**Delineation of Potential Jurisdictional
"Waters of the United States"
(Section 404 of the Clean Water Act)**

**LEONA QUARRY SITE
Oakland, California**

June 2001

RECEIVED
JUN 20 2001
ENVIRONMENTAL
& DESIGN SERVICES

Appendix B - Jurisdictional Delineation Map

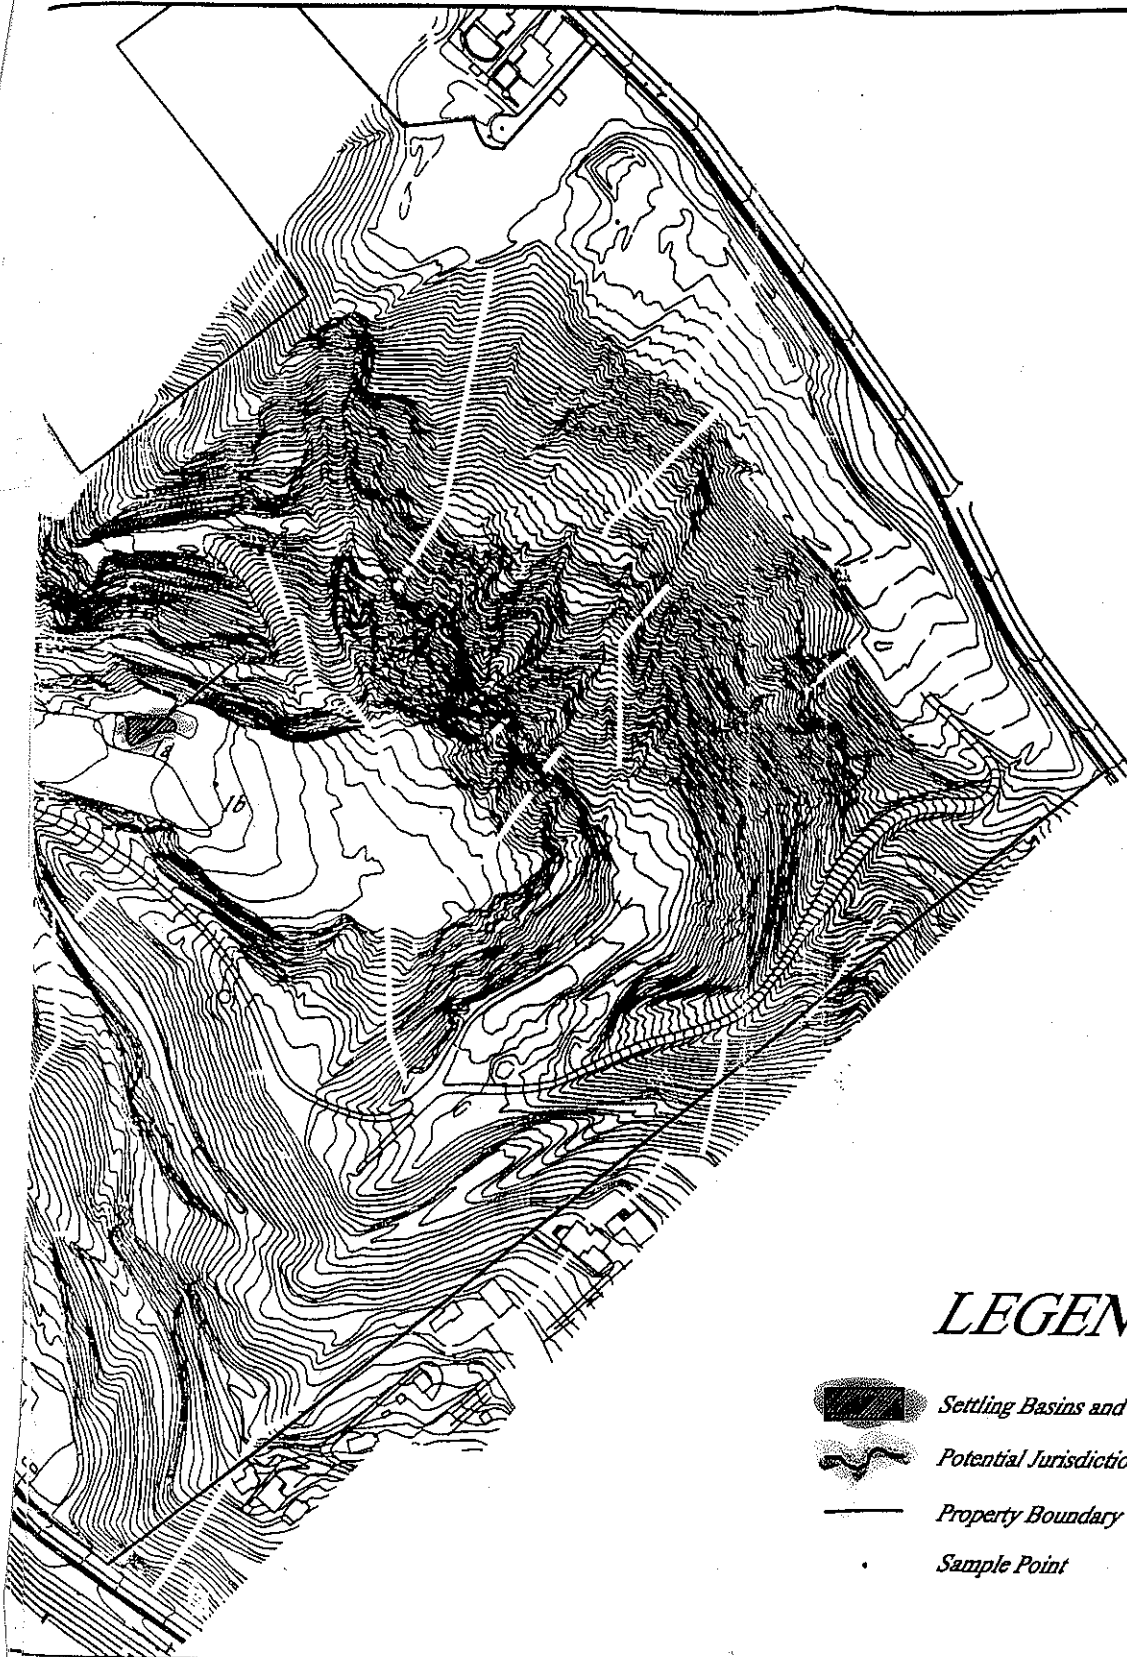
*Its not "dry land"
its damming a
creek to make the
pond.*

*Since they determined
that this was a potential
jurisdictional water - why
didn't they contact
DFG?*
